Response template for consultation on the Administration of the Green Gas Support Scheme

Organisation Name:	Anaerobic Digestion and Bioresources Association (ADBA)
Organisational Type:	National Association
Completed by:	Nick Primmer
Contact details:	Nick.primmer@adbioresources.org

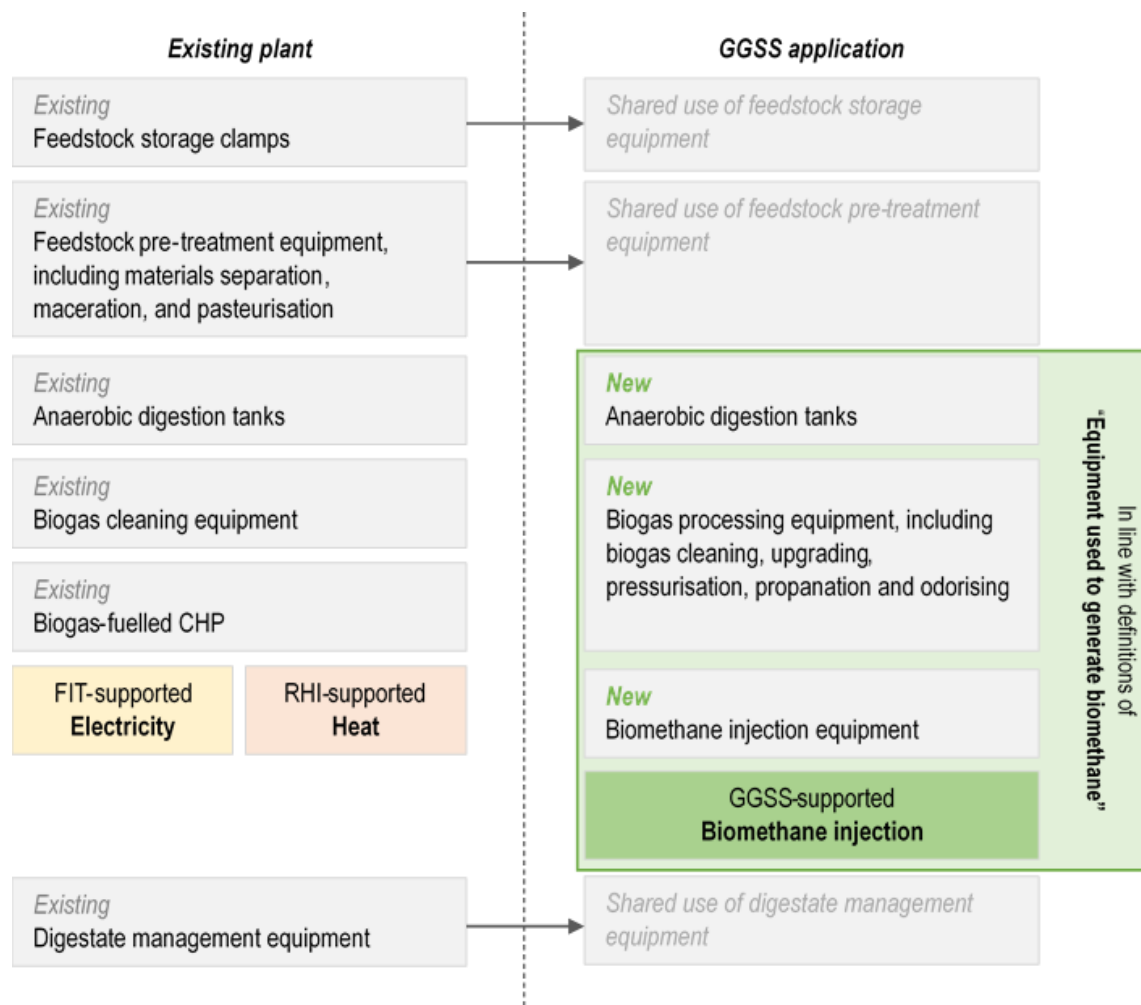
Based on the definitions outlined in the consultations, the following AD plant schematic depicts the maximum amount of equipment which could be shared with an existing AD plant, and remain eligible for the GGSS:

As suggested by the diagram, a new GGSS-supported biomethane plant could be built alongside an existing CHP plant, sharing all equipment which has not been deemed 'used to produce biomethane'. While BEIS has stated that "expansions and conversions from CHP equipment will not be eligible [for GGSS]", this diagram portrays two AD plants working together to enhance operational efficiency, mitigate economic risk, and optimise the production of renewable energy.

ADBA believes that this example AD plant (see diagram) would not constitute an 'expansion or conversion' of an existing CHP plant. The CHP would continue to operate business as usual, generating renewable electricity in line with its FIT accreditation; the original digesters would continue generating biogas to fuel the FIT accredited CHPs. The same feedstocks are processed with the same potential for renewable electricity generation. The GGSS accredited development would run alongside this existing plant, sharing equipment only where possible. The construction of new digesters would increase the feedstock capacity, and all their biogas upgraded to biomethane ready for injection.

Under this scenario, biogas should *not* be mixed or redistributed between the FIT accredited and the GGSS accredited digesters. Ofgem's annual sustainability audit can verify that all biogas is correctly diverted to the appropriate end-use – i.e. CHP or grid injection in line with the relevant support schemes.
